U. S. Department of Labor

Subject: Proposed Update of the Roof-Control Plan for, Upper Big Branch
Mine-South, I.D. No. 46-08436, Performance Coal Company,
Montcoal, Raleigh County, West Virginia.

Your updated roof-control plan received May 19, 2008, has been reviewed and cannot be approved as submitted. The following is a list of deficiencies that must be addressed:

MINIMUM ROOF CONTROL PLAN

Barrier Extraction Plan #1

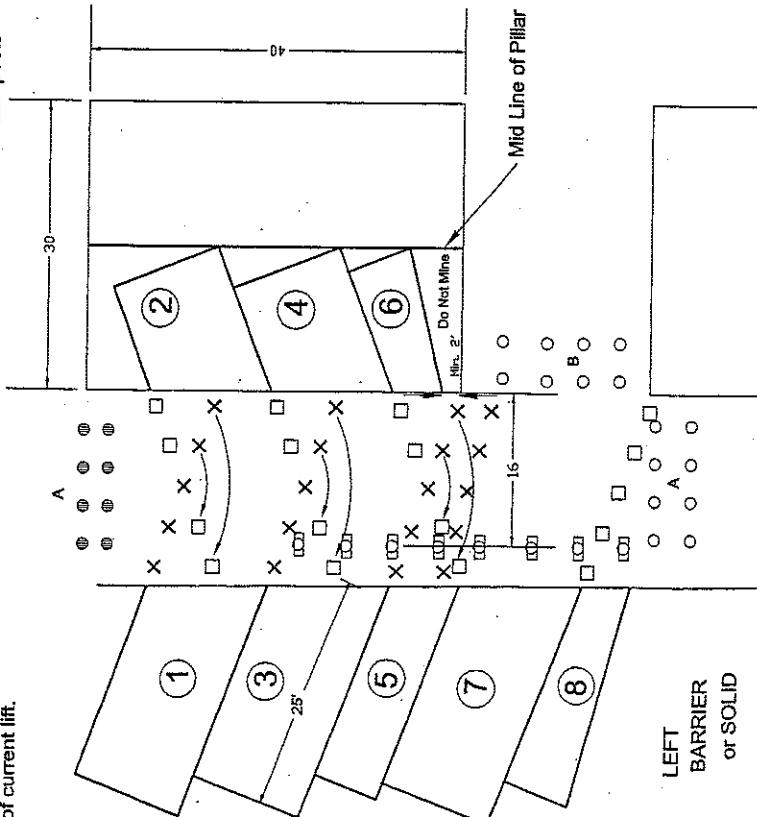
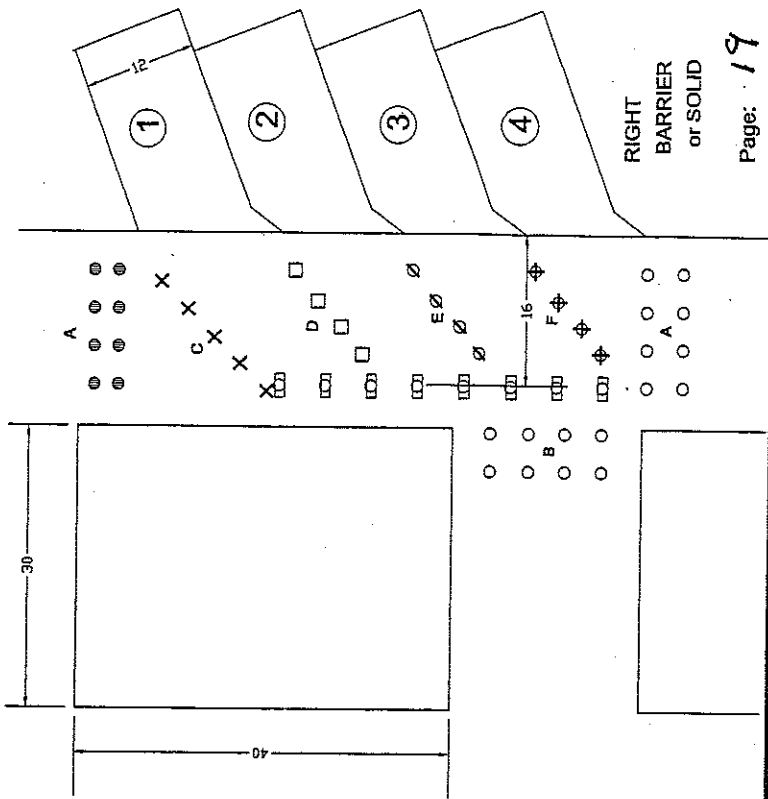
12. Page 19, Drawing "Barrier Extraction Plan #1" The turn posts are shown incorrectly turn posts "C" should be in the shape of a "V" for cuts 1, 3, & 5 and turn posts "D" should only complete from the bottom of the "V" to make turn posts for cuts 2, 4, & 6 for left side drawing. The Drawing on Page 20 has the same problem, but for the right side drawing.

MRS Canopy Extension No Scale

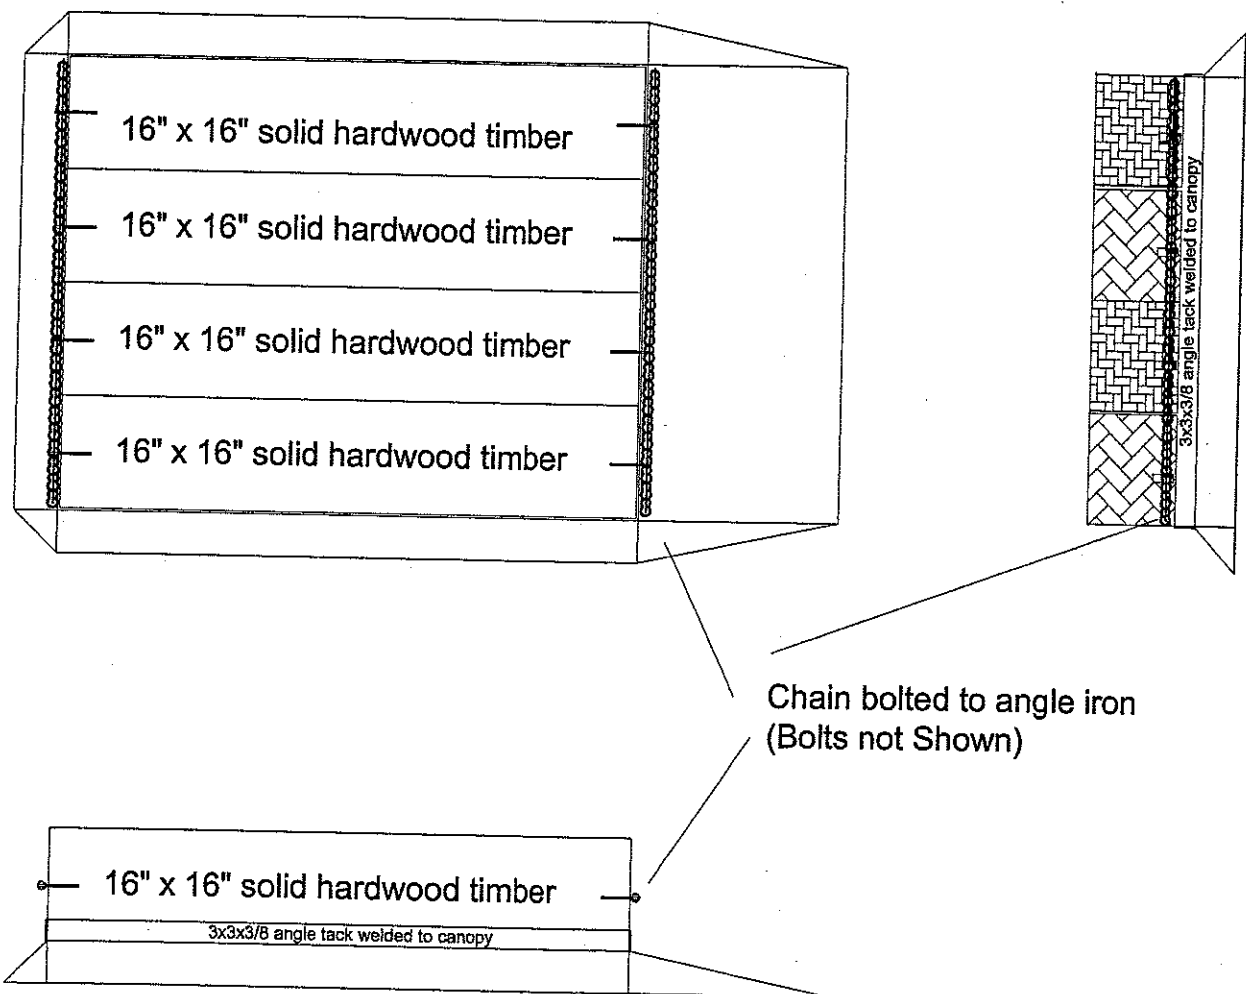
11. Page 7, Item 12 - Safety Precautions for Mobile Roof Support Systems, also needs to include the following statements:

Mined heights in excess of the working range of MRS units shall be anticipated and addressed using OEM extensions. However, in isolated (unanticipated) cases, when the MRS units cannot be set firmly against the roof, extensions meeting the following criteria may be used to increase the reach of the MRS units:

- a) The extensions shall not exceed 18 inches in height, and shall be constructed from a single layer of wood blocks, placed skin-to-skin.
- b) The wood blocks shall either be hickory, white oak or red oak and shall be replaced when damaged.
- c) The wood blocks shall be restrained by channel or angle iron tack-welded to three sides of the MRS roof contact plate, and held in place by chains, straps, or other equivalent means.

Wood extensions as a means of extending the reach of the MRS unit shall only be used for a maximum of three rows of pillars, and then a manufacturer approved extension must be used.
